Lee County, Florida
DEPARTMENT OF COMMUNITY DEVELOPMENT
ZONING SECTION
STAFF REPORT

Case Number: DCI2021-00053

Case Name: RaceTrac Bayshore Rd

Case Type: Planned Development Rezoning

ATTACHMENT D

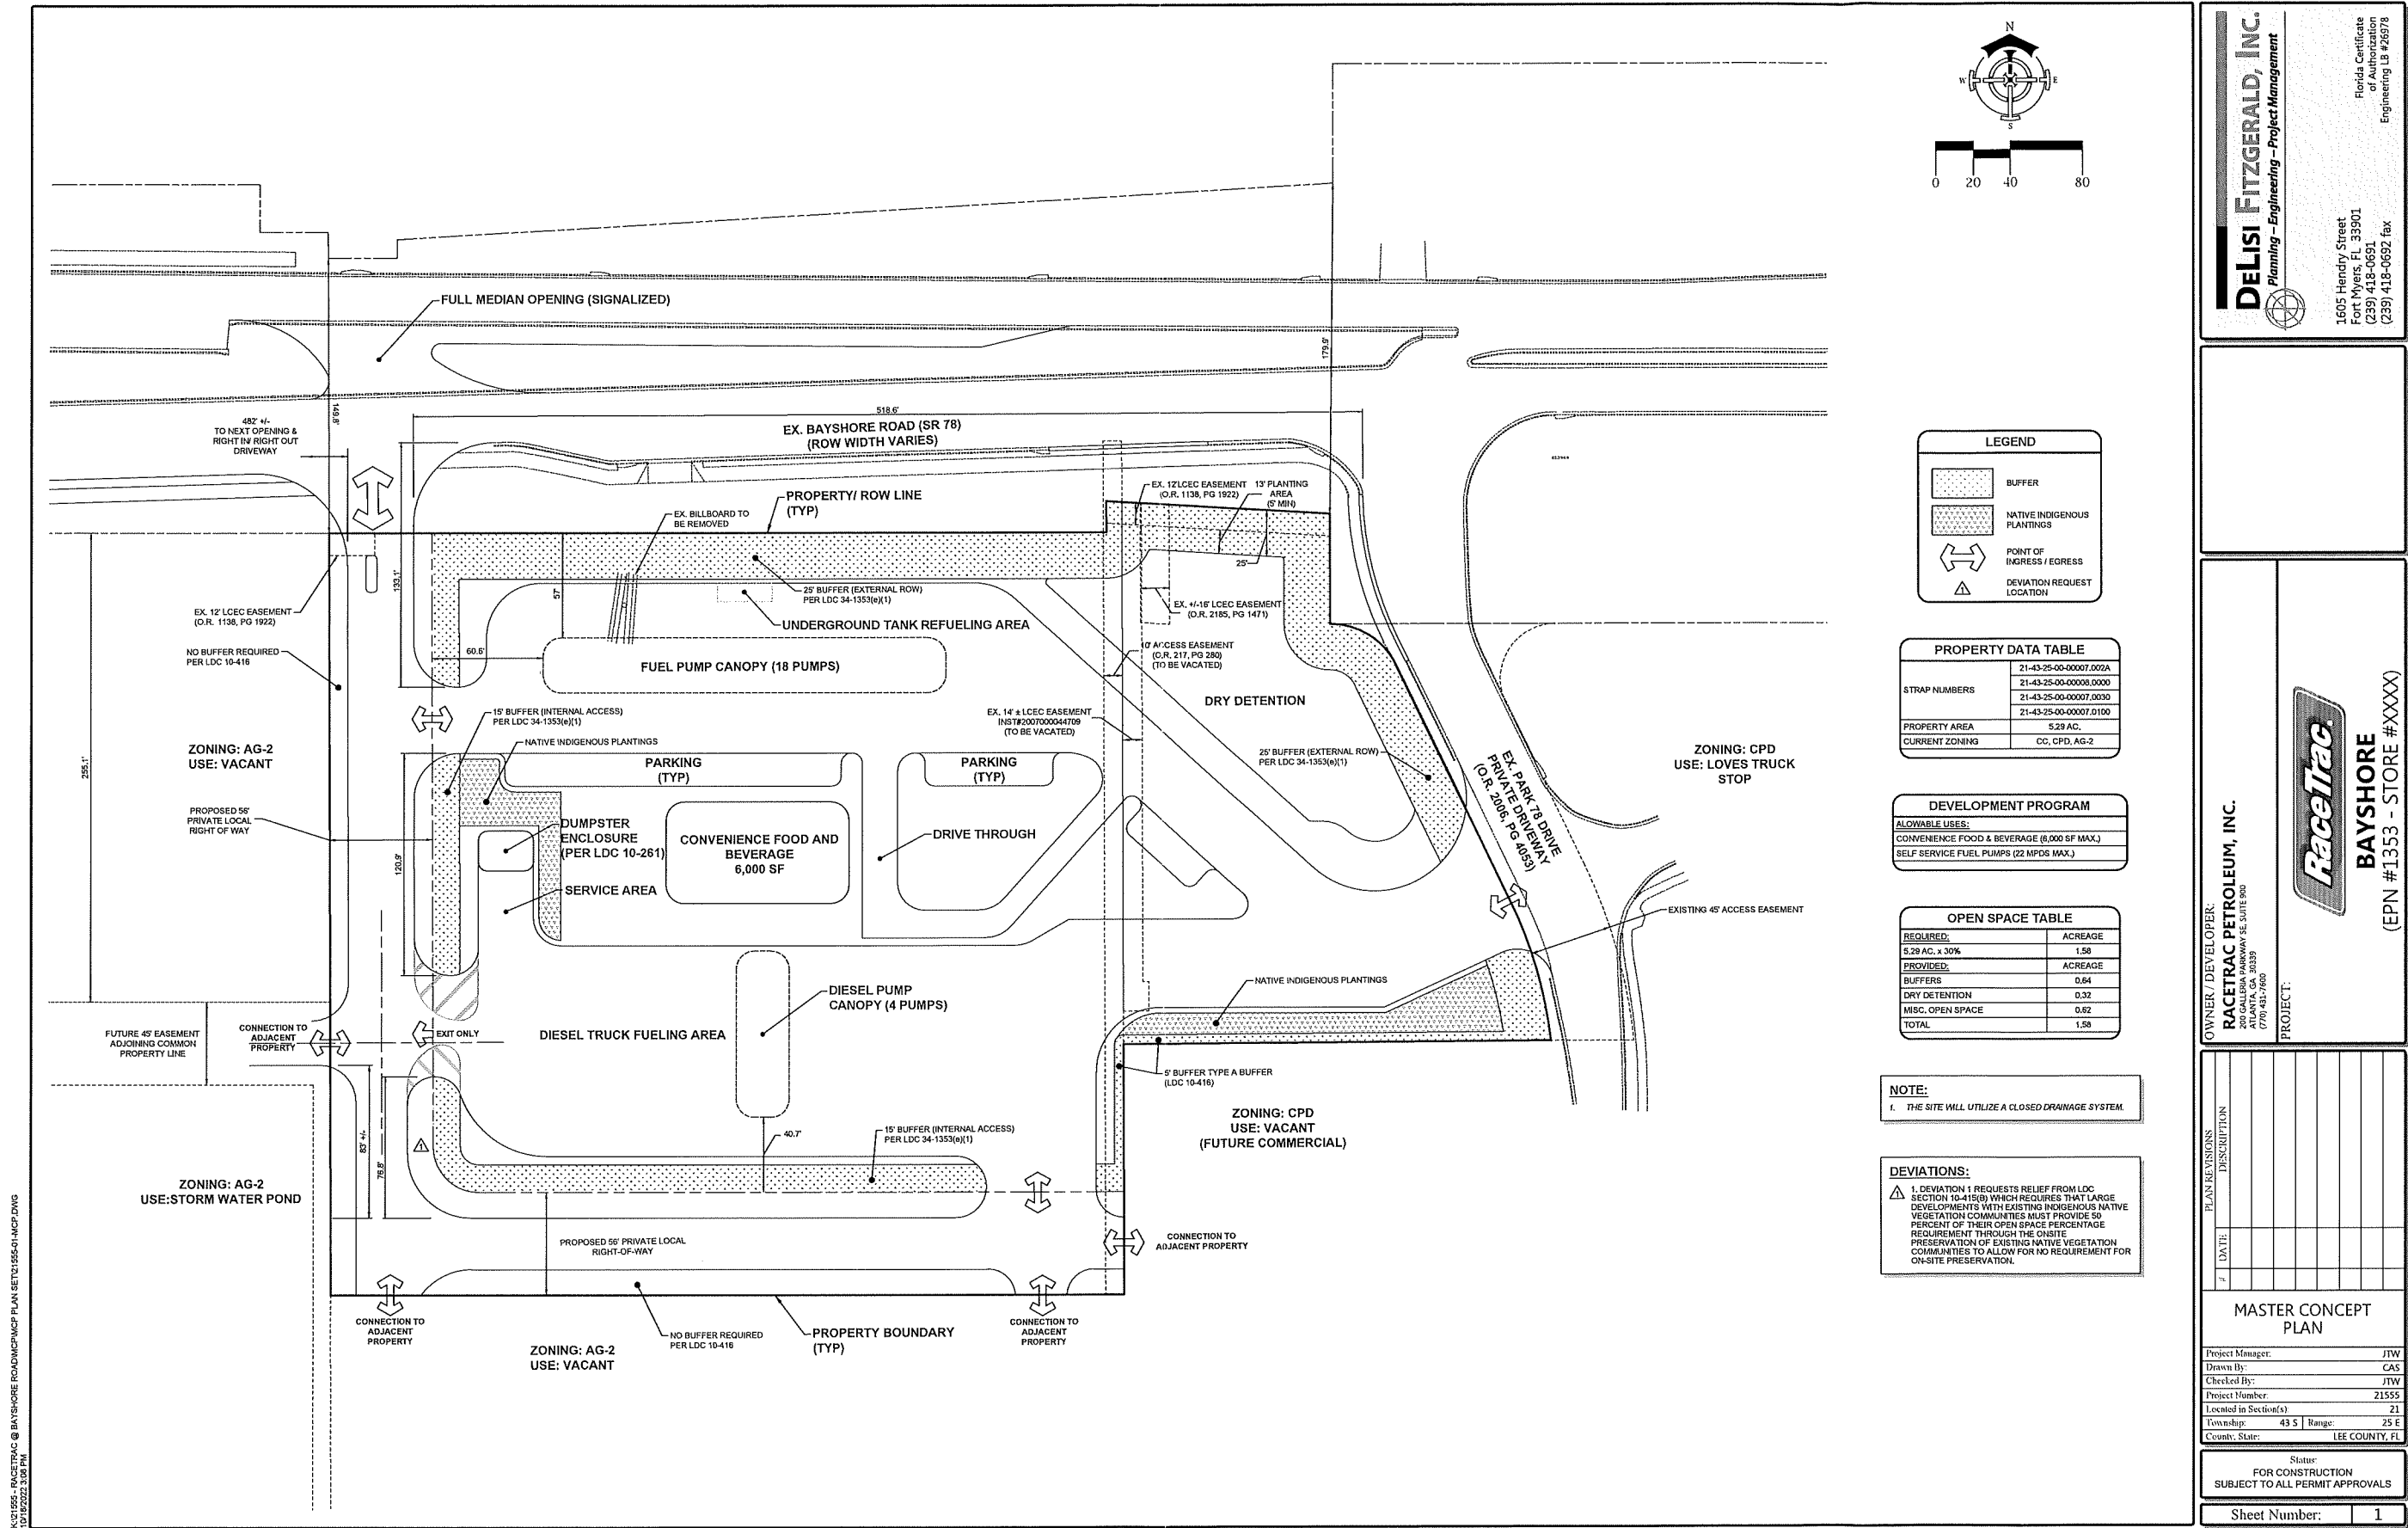
During substantive review, staff identified revisions to the MCP, which included notation of a drive-through along the east side of the convenience store. This change was not reflected in the revised schedule of uses or project narrative and staff has concerns with respect to the inclusion. Upon this

If the applicant desires the use of a drive-through, staff recommends the applicant elect to continue the hearing before the Hearing Examiner in order to provide further traffic analysis concerning the use of a drive-through in conjunction with a convenience food and beverage store.

¹ A revised MCP is required to align with staff's recommendation to exclude the drive-through facility unless the applicant elects to continue the hearing to further support the drive-through facility.
